January 20, 2009

RE: Grant ID: UR8100206

This is a request for a Class II Permissive Change under Section 15.204 [c][1] for the Blind Spot Detection Sensor. The reason for this request is due to some changes on the transmit board as outlined below. This modified sensor is referred to as the Gen2A design.

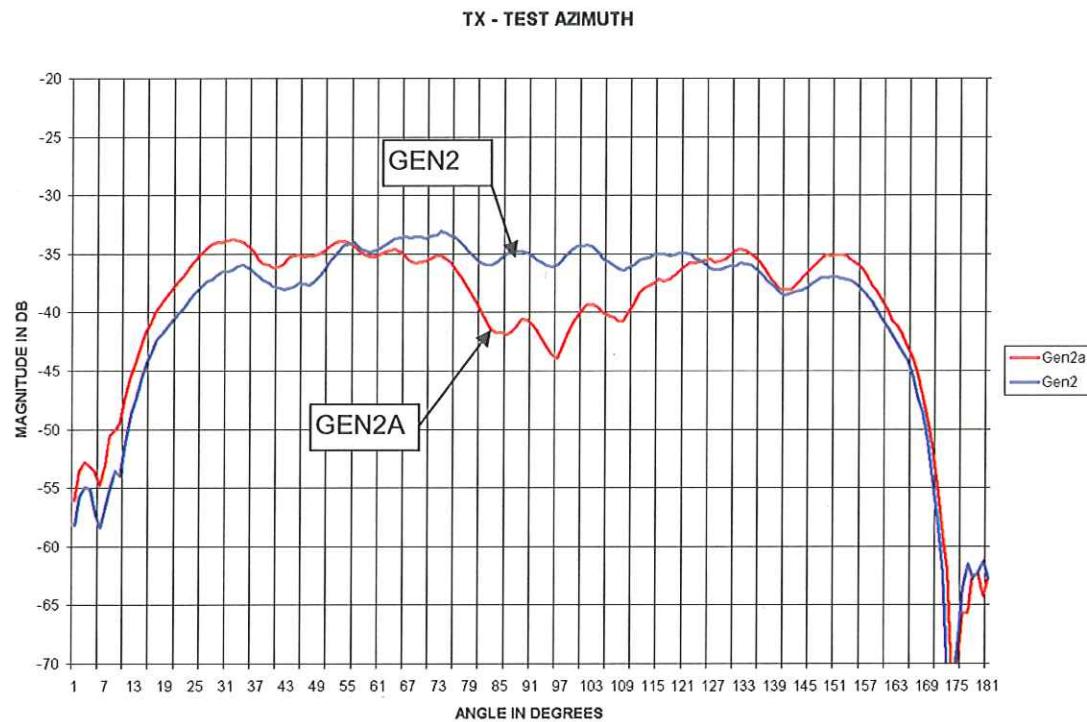
The transmit board for the Gen2A sensor was modified as shown below. The ground opening was pulled away from the antenna patch 0.84mm further than the Gen2 board. There were no changes to the electrical components and the schematic did not change.
